Development Review Board

Tuesday, June 17, 2025, 5:00 PM

TO: Development Review Board
FROM: Scott Gustin
DATE: June 17, 2025
RE: ZP-25-113; 43 Mansfield Avenue

Request: Proposed demolition of existing one-story addition to construct a new two-story addition with associated site improvements.

MATERIALS AND
LAYOUT PLAN

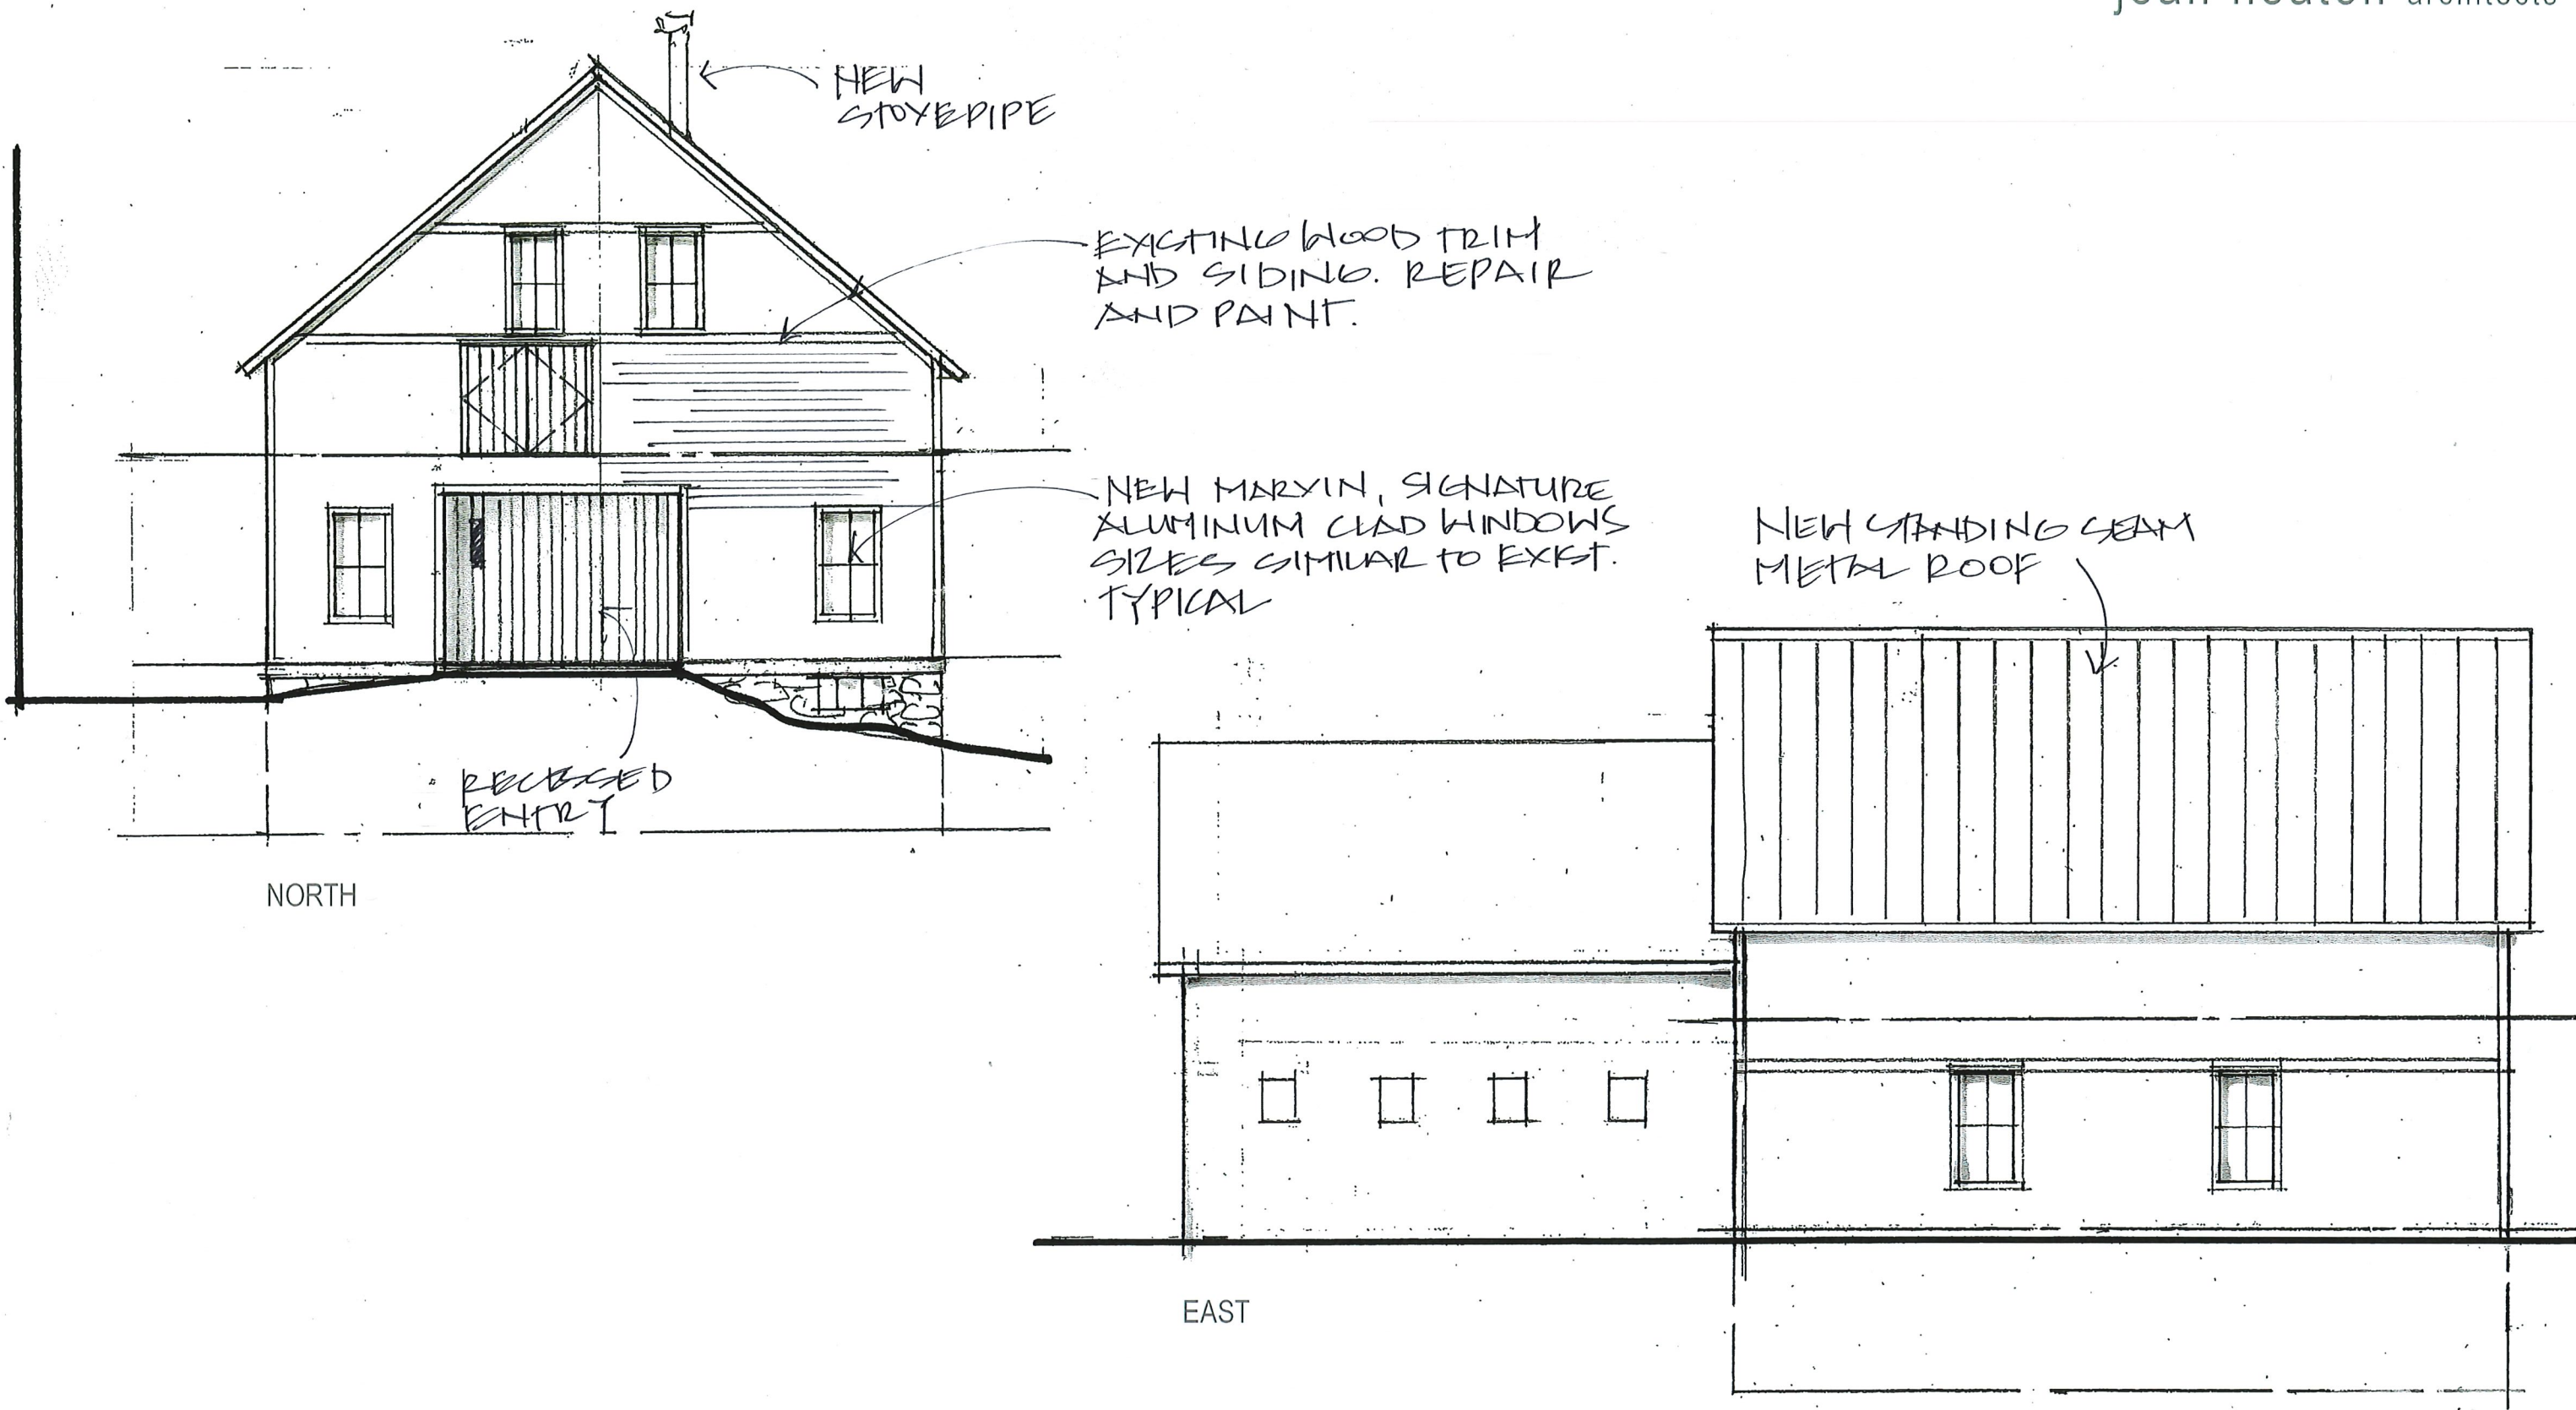
This parking plan (Wagner Hodgson) appears to increase the amount of lot coverage and may have to be minimized. The parking arrangement will require vehicles to back out onto Jackson Court, but that is an existing condition. Parking is laid out at the side (or rear) of existing structures. The granite walk may not be sufficient to keep vehicles from parking on green space.

2. Any existing non-conformities may be retained, but not expanded. Lot coverage shall not exceed 49%, as previously acknowledged and approved. **The applicant shall provide an accurate calculation of proposed lot coverage prior to decision by the DRB.**

SCHATZ | SCHEMATIC LANDSCAPE PLAN

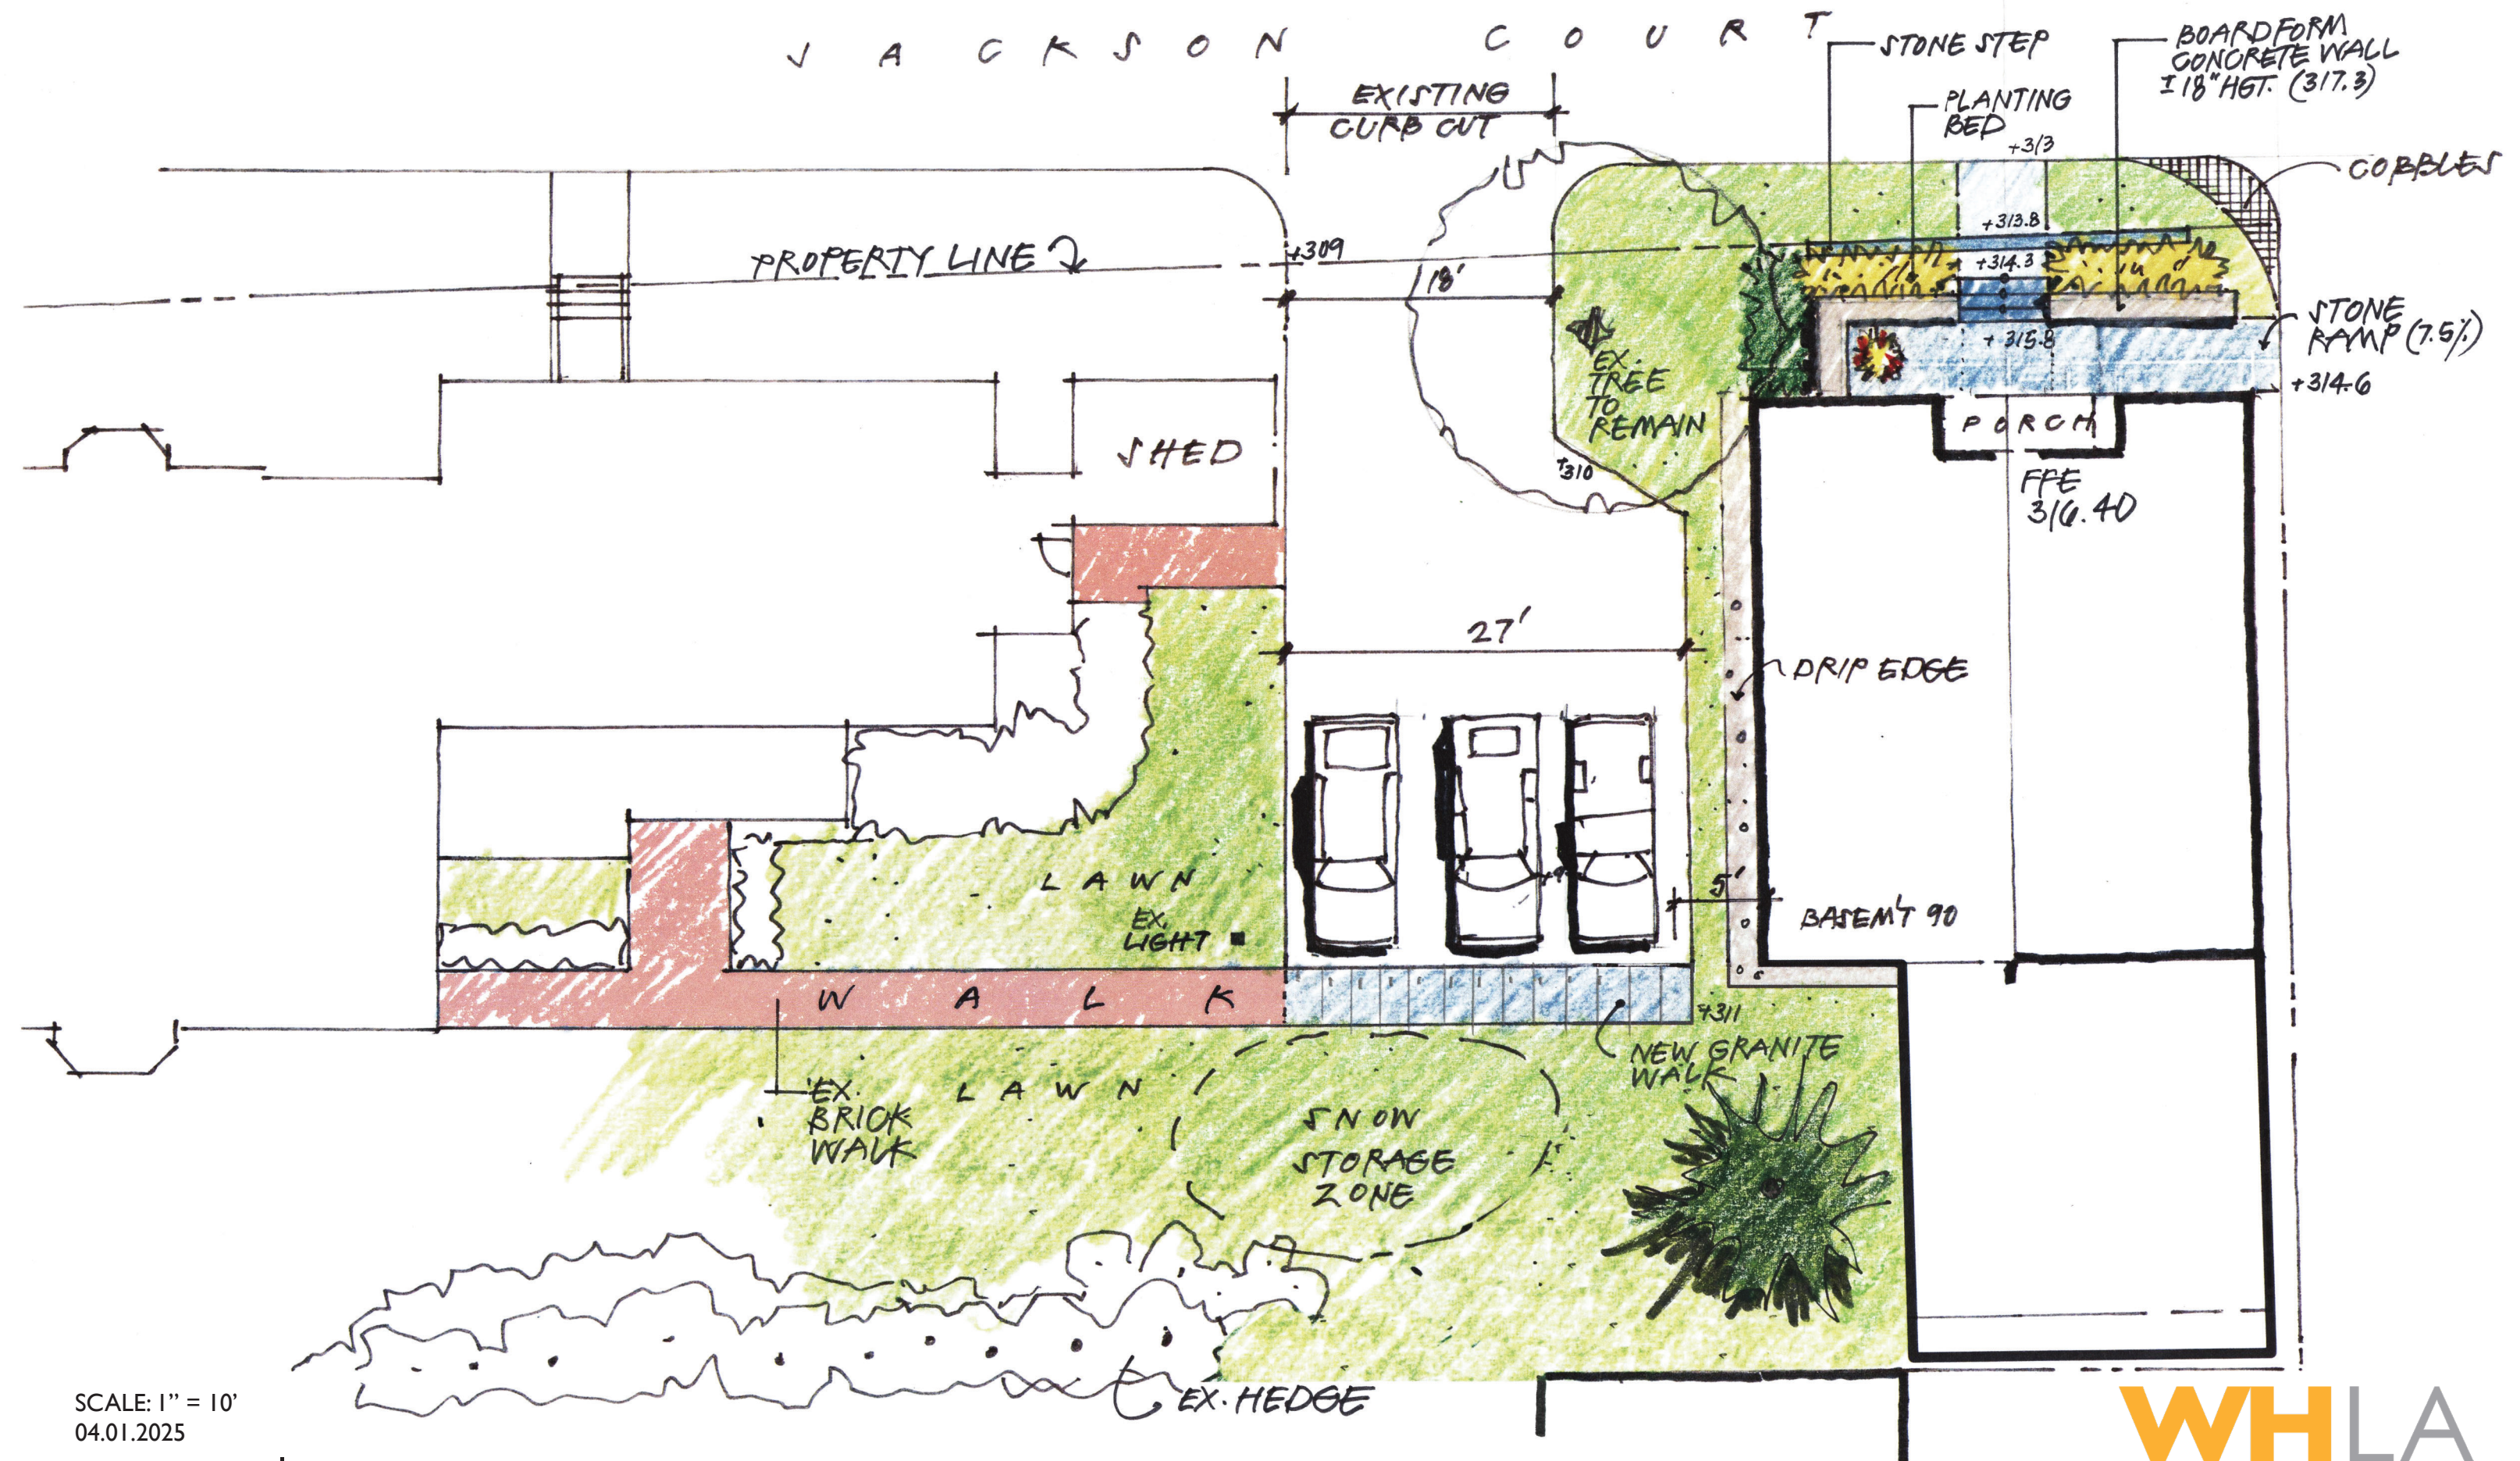
An existing tree adjacent to the carriage barn will be retained. The landscaping plan includes the addition of a stone ramp accessed from a neighboring property. As the access proposed is outside the parameters of this parcel, an access easement is warranted.

A south boundary line is not illustrated on the landscape plan. After review of a prior approved site plan, confirmation is needed that the snow storage zone lies within this parcel’s boundary line. No finding possible.

3. The submission defines pedestrian access from an easterly parcel. Either an access easement shall be obtained from that property owner, or the entry plan shall be revised to reserve all access between the ROW and the residence on this parcel.
